3.0 CORRECTIONS AND ADDITIONS TO THE DRAFT EIR

1. ALTERNATIVE 5: MODIFIED PLANNING AREA 1 ONLY ALTERNATIVE

Cielo Vista Project

Alternative 5 Land Use Plan

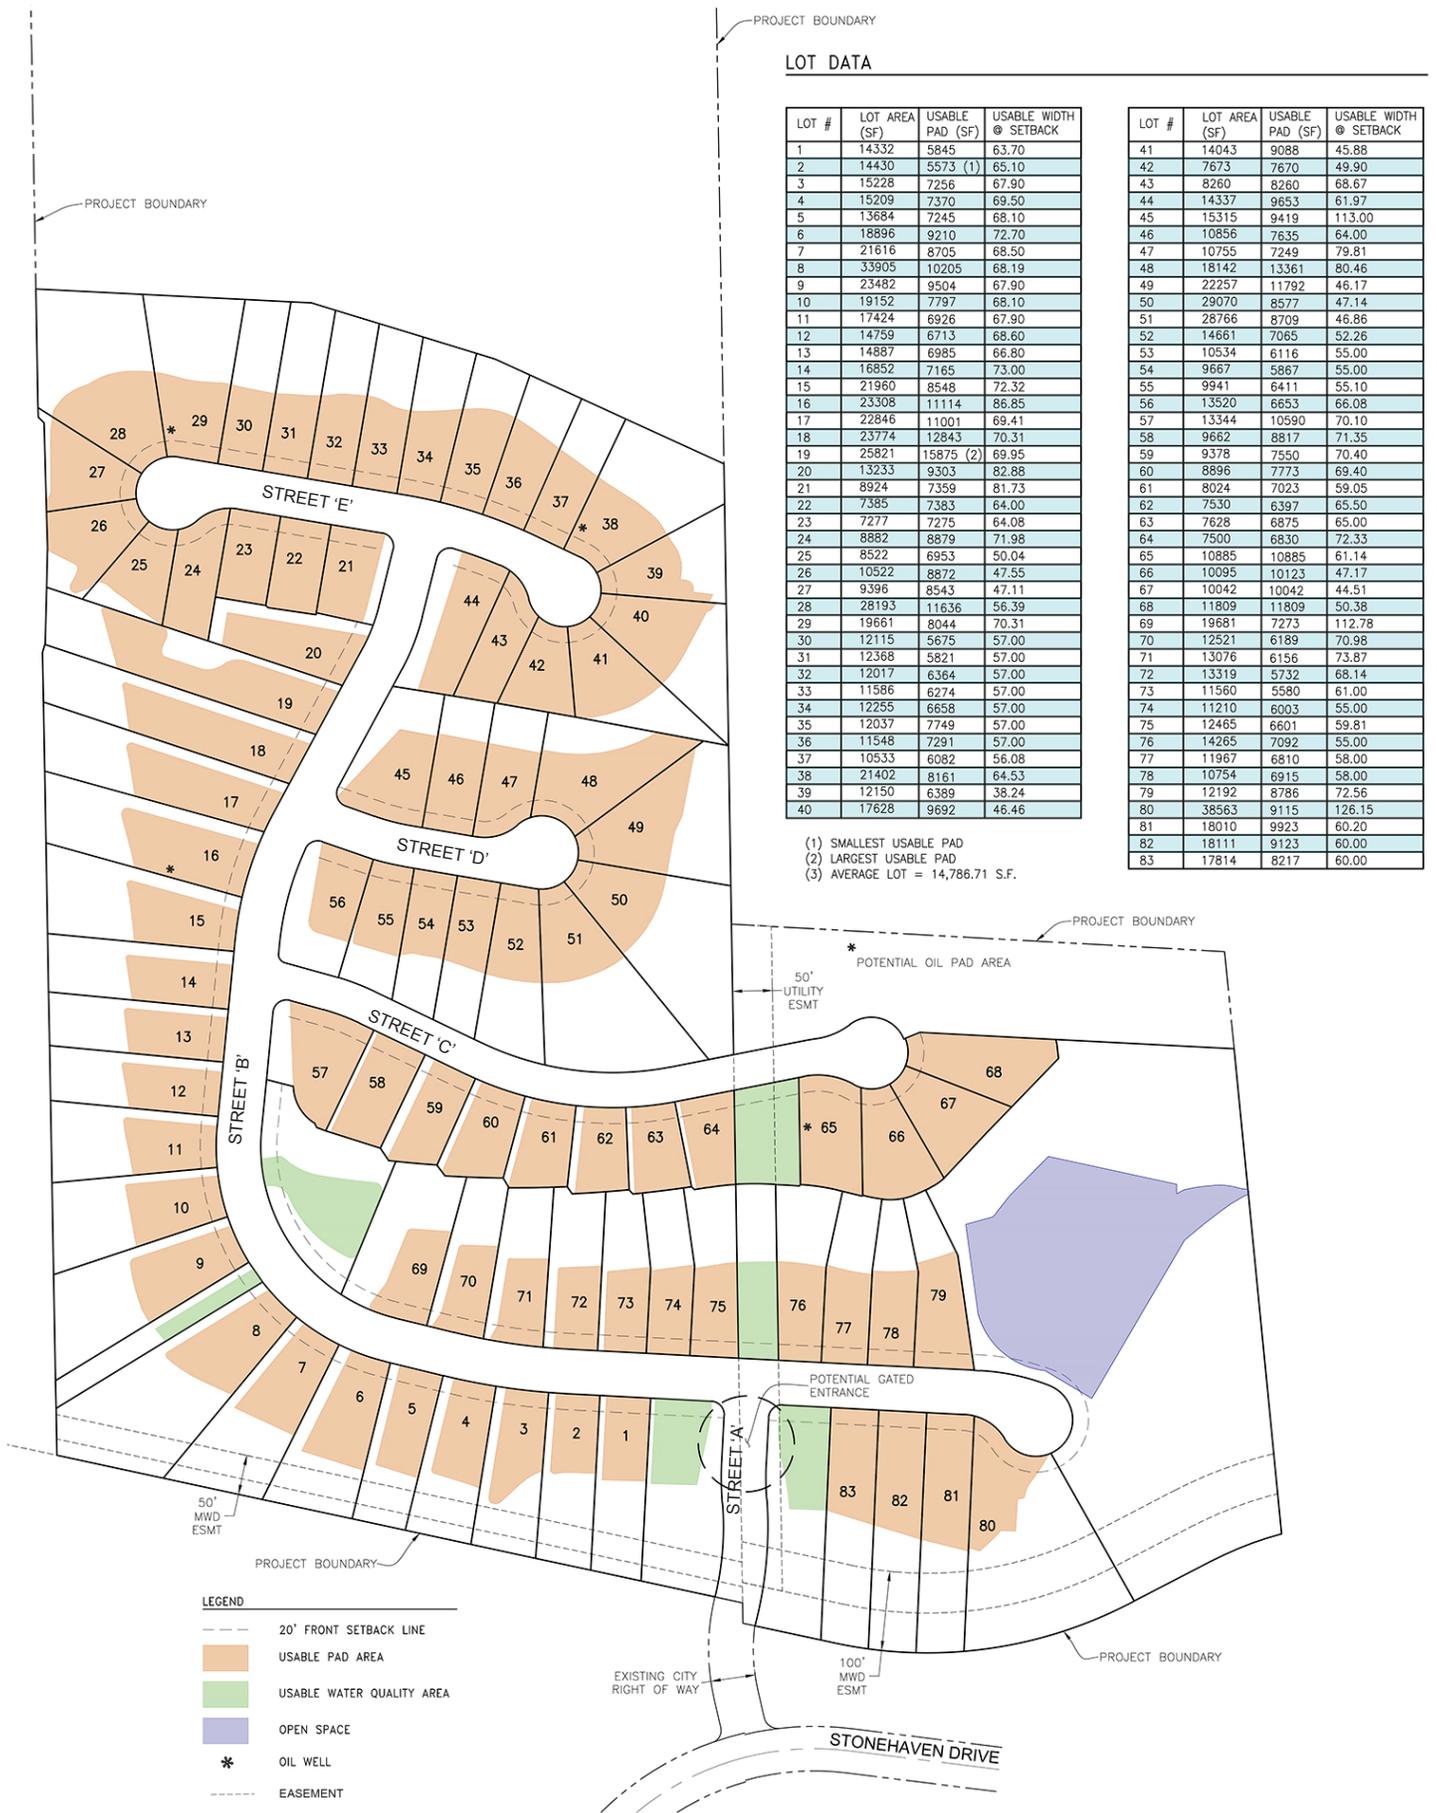
As shown on **Figure 3-1**, *Alternative 5 Land Use Plan*, the Modified Planning Area 1 Only Alternative (Alternative 5) would not include development of Planning Area 2. **Figure 3-2**, *Alternative 5 Site Plan*, illustrates the site plan for Alternative 5. Alternative 5 would develop Planning Area 1 with 83 single-family residential lots and associated improvements. Alternative 5 would have a gross density of 1.0 dwelling units per acre and would occupy the same 41.3 acres of the project site associated with Planning Area 1, with 42.7 acres of the site preserved as permanent open space. Like the Project, access to Planning Area 1 under Alternative 5 would be from Via del Agua to the south of the project site. Alternative 5's site access and internal street network (which would be privately owned and maintained) would be the same as with Planning Area 1 under the proposed Project. The reduction in the number of lots in Planning Area 1 compared to the Project would occur because of wider residential lots. The overall extent of grading, landscaping, lighting, utilities, and other project design features associated with Alternative 5 would be less than the grading, landscaping, lighting, utilities, and other project design features associated with the Project given that, unlike the Project, Alternative 5 does not propose any development on Planning Area 2. As with the Project, existing on-site oil wells and facilities would be abandoned or re-abandoned in connection with Alternative 5. Also as with the Project, a 1.8-acre oil drilling pad would be developed for future development as a separate project should the oil operators choose to relocate to this area of the project site under this Alternative. Thus, all oil-related activities associated with Alternative 5 would be same as the Project.

Overall, compared to the proposed Project, due to the elimination of Planning Area 2 and reduced density in Planning Area 1, Alternative 5 would include 29 fewer units, would reduce the area of development by 6.4 acres, and would increase permanent open space by 6.4 acres. Alternative 5 would provide for a gross density of 1.0 units to the acre, which is consistent with the density requirements under the Yorba Linda General Plan, compared to 1.3 units to the acre under the Project. This Alternative would also be consistent with the existing General Plan for the County of Orange, which designates Planning Area 2 as Open Space.

The land use plan for this Alternative also reflects a potential access corridor contemplated by the Esperanza Hills Specific Plan, which is considered to be a related project for purposes of the Alternative 5 cumulative

2-1

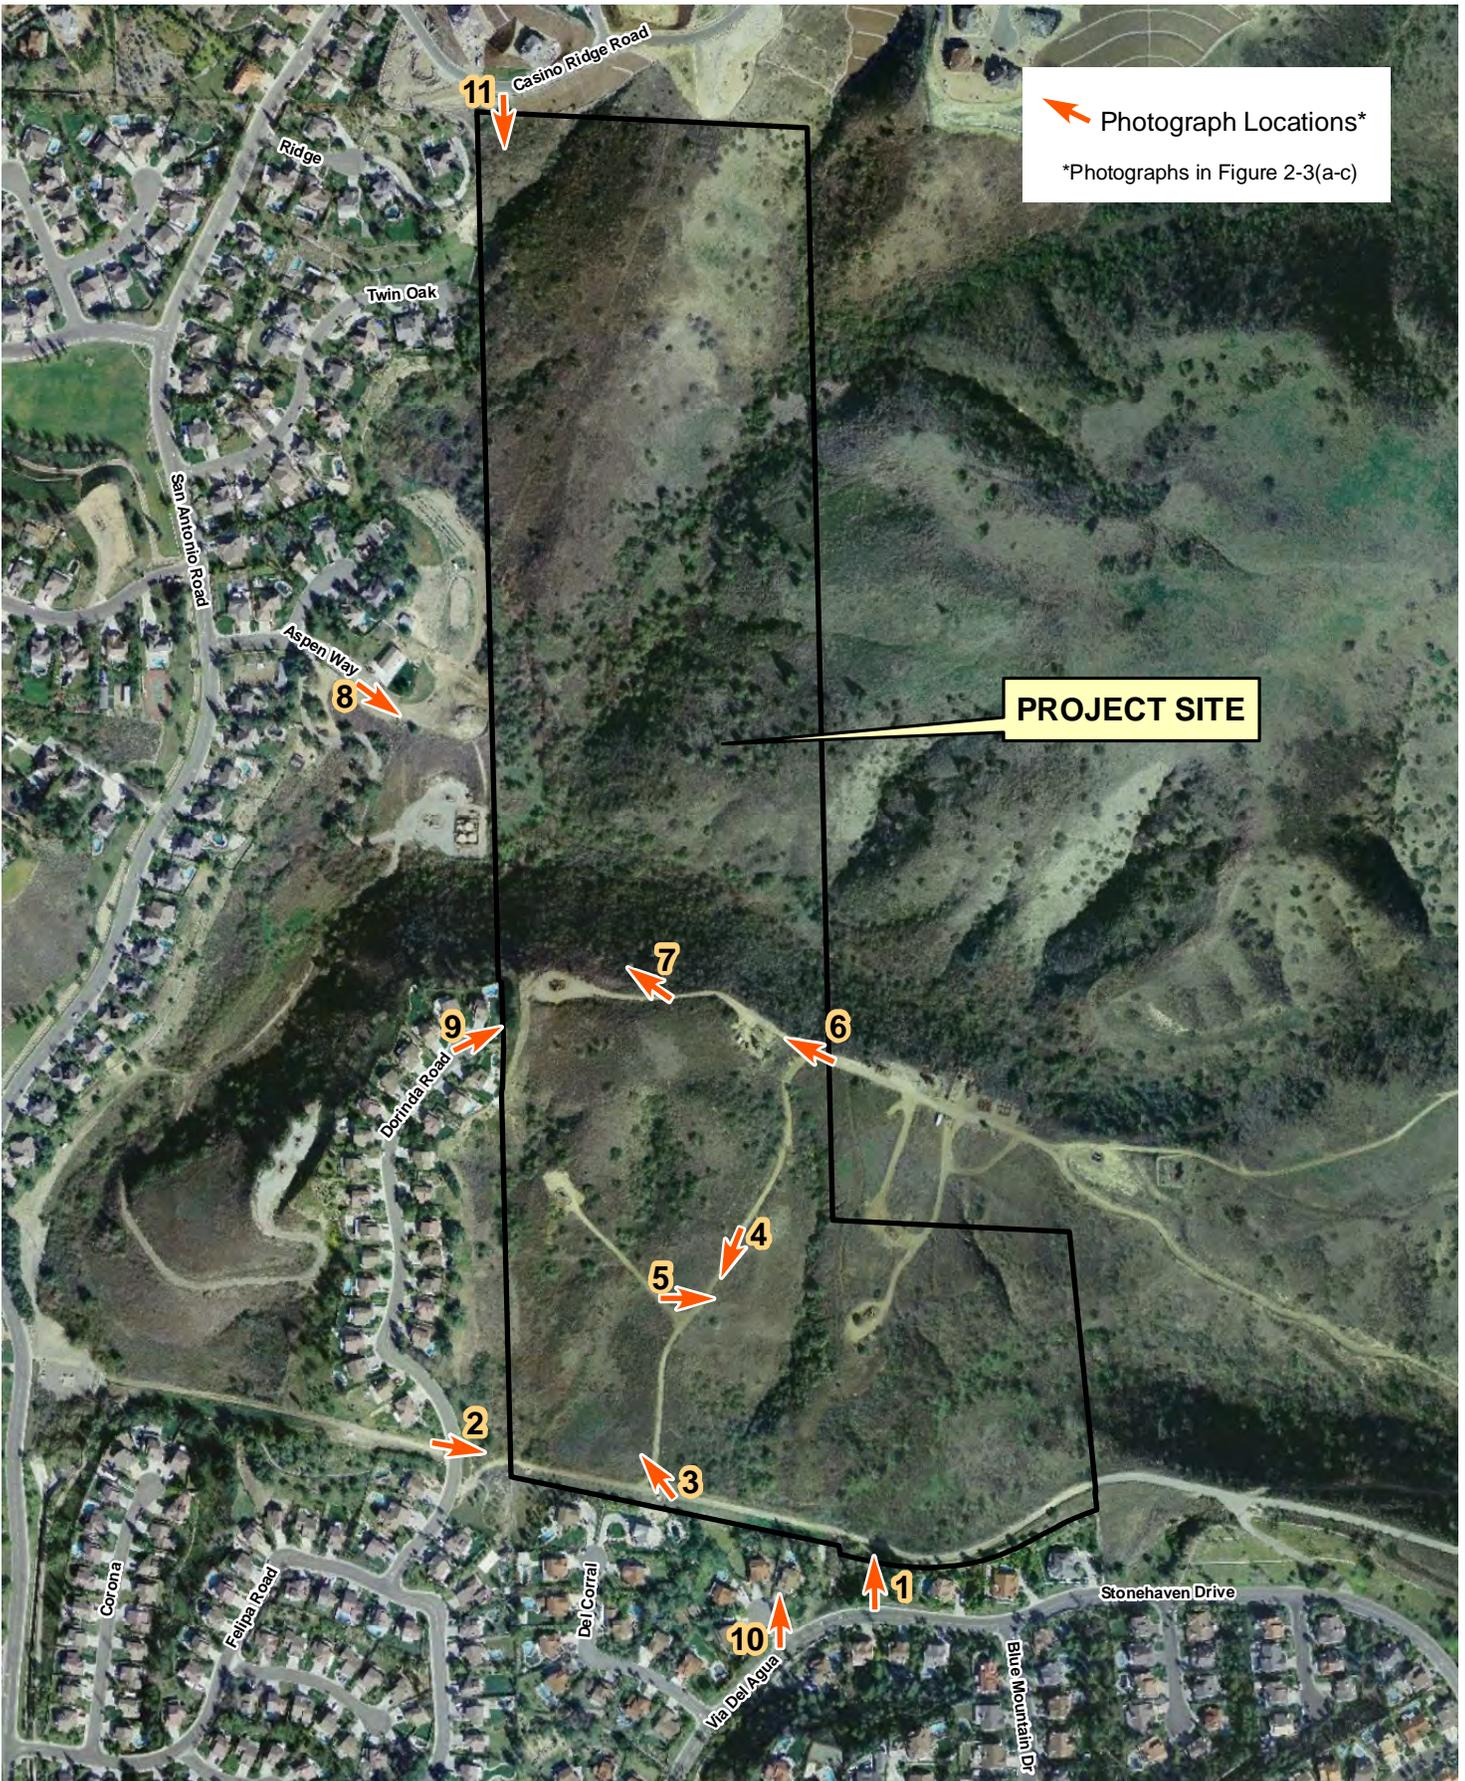
3. Page 2-3 and 2-4. Modify Figures 2-1 and 2-2 to illustrate correctly illustrate southern project site boundary. Figure 2-1 also shows the on-site zoning designations.

The revised Figures 2-1 and 2-3 are shown on the following pages. Figure 2-1 has been revised to illustrate the on-site County zoning designations. The southern boundary in both figures has been revised to include APN 351-852-05, a 50-foot wide parcel spanning the easterly portion of the southern project site boundary. This parcel was inadvertently omitted from the Draft EIR's exhibits, but was accounted for in the Project impact analysis throughout the EIR. The building footprints and lots proposed by the Project would remain as presented in the Draft EIR. This parcel would be subject to applicable fuel modification requirements. No significant revisions to the EIR text/analysis due to the graphical error are necessary. Because the boundary revision does not affect the analysis, mitigation measures or impact conclusions presented in the Draft EIR, further revisions to the figures in the Draft EIR would not provide meaningful data or insight regarding the significance of the impacts evaluated in the Draft EIR. Accordingly, further revisions to the figures in the Draft EIR are not necessary.

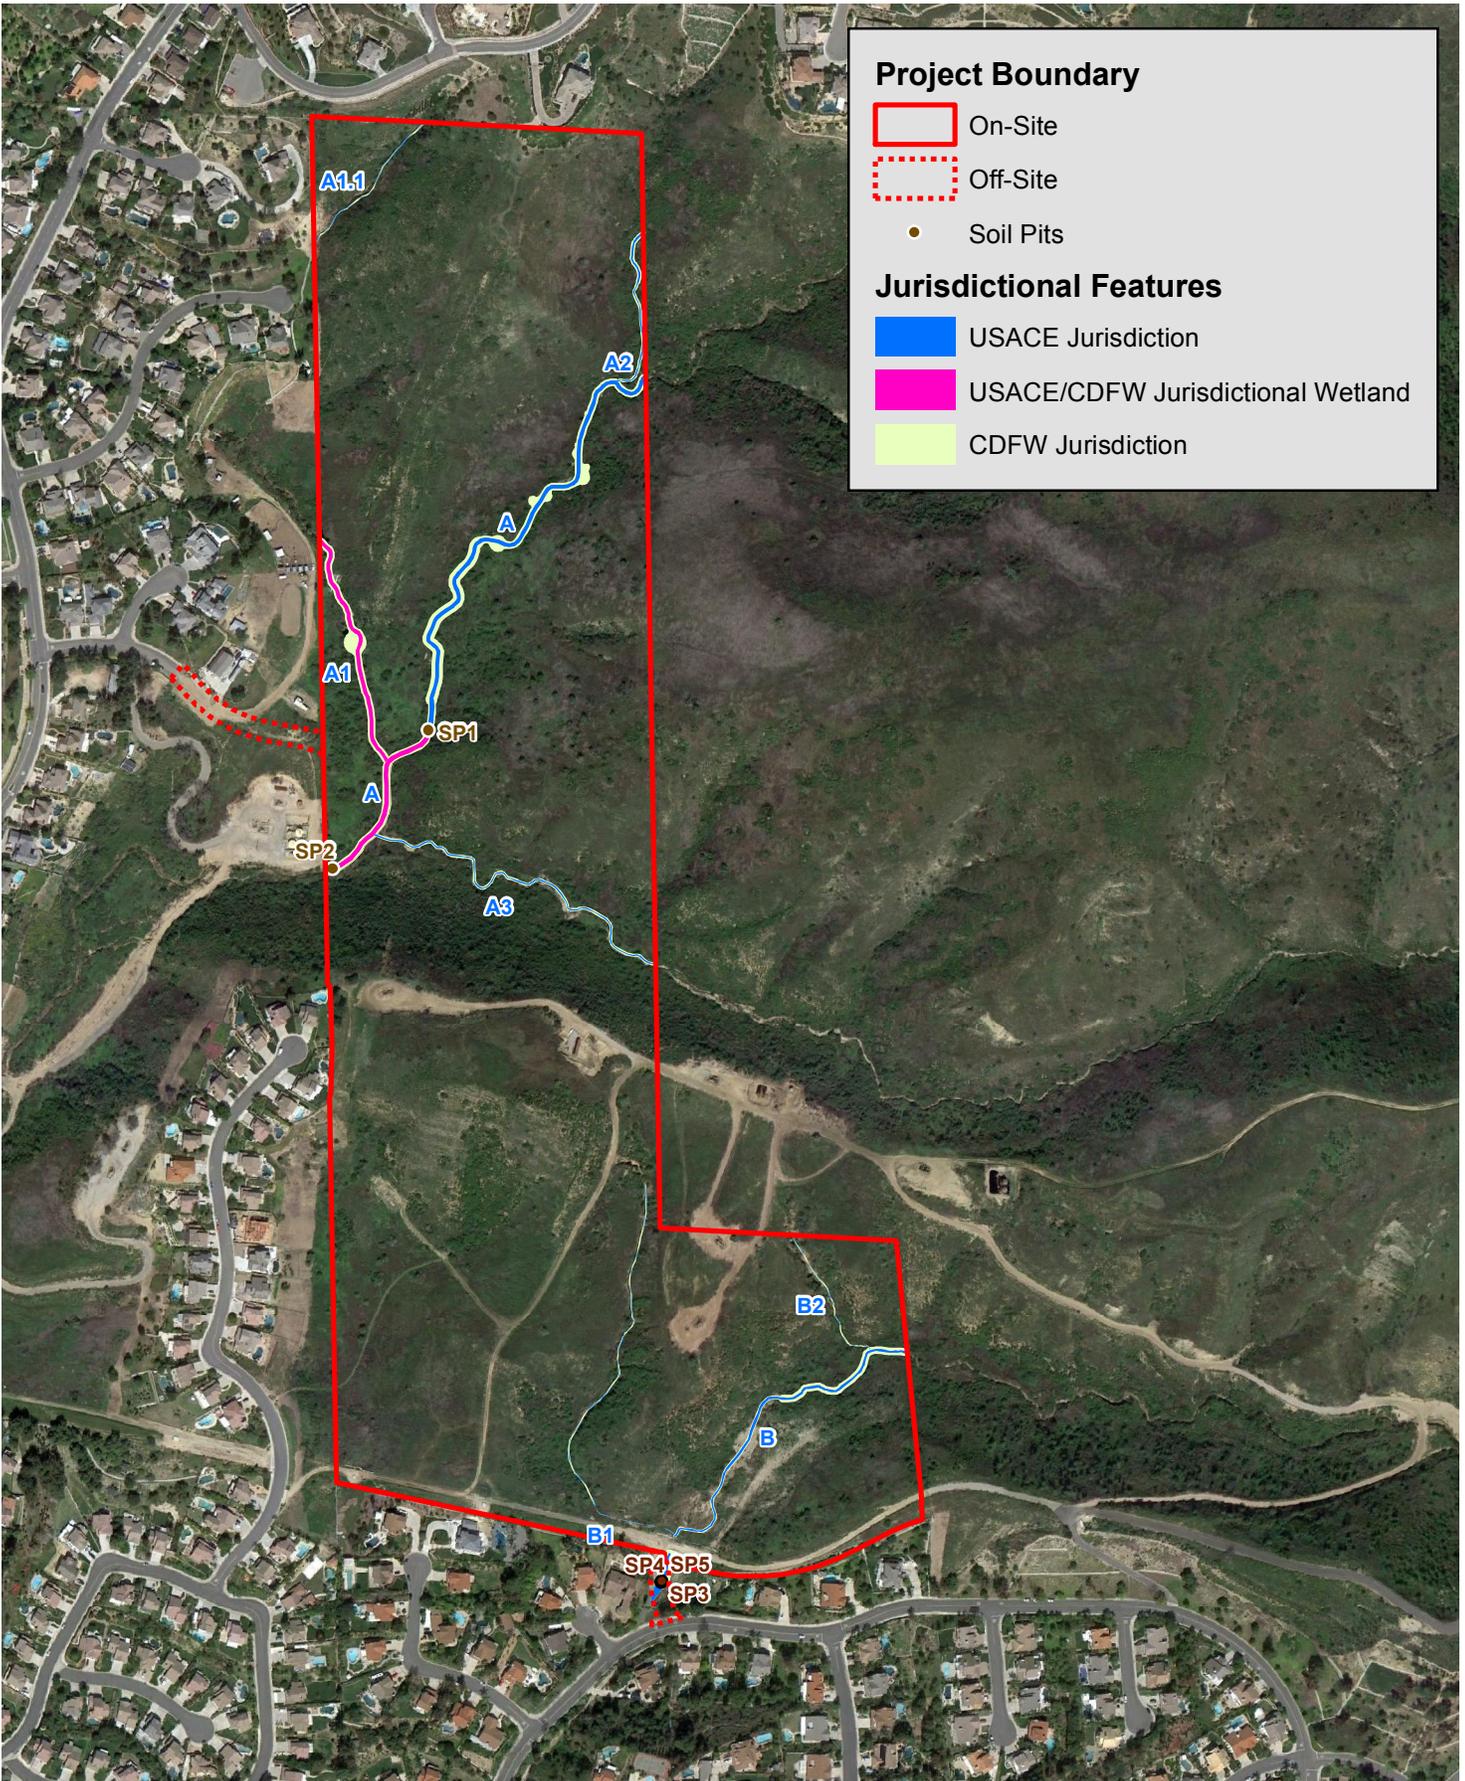
⁸ *The nominal increase in linear feet and acreage of the jurisdictional features is due to the extension of Drainage B near the southern project site boundary as shown in the revised Figure 4.3-4. This nominal increase is a minor technical clarification to the Draft EIR analysis. This increase does not represent a substantial increase in the severity of impacts evaluated in the Draft EIR, does not result in new significant impact, and does not change the mitigation measures prescribed in the Draft EIR. According, this does not constitute "significant new information" added to the EIR.*

4. **Page 4.3-22. Revise Figure 4.3-4 to correctly illustrate Drainage B near southern project site boundary. This correction also applies to Figure 7 on page 24 of the BRA and Figure 5 on page 21 of the Jurisdictional Delineation included in Appendix C of the Draft EIR.**

See revised Figure 4.3-4 on following page.
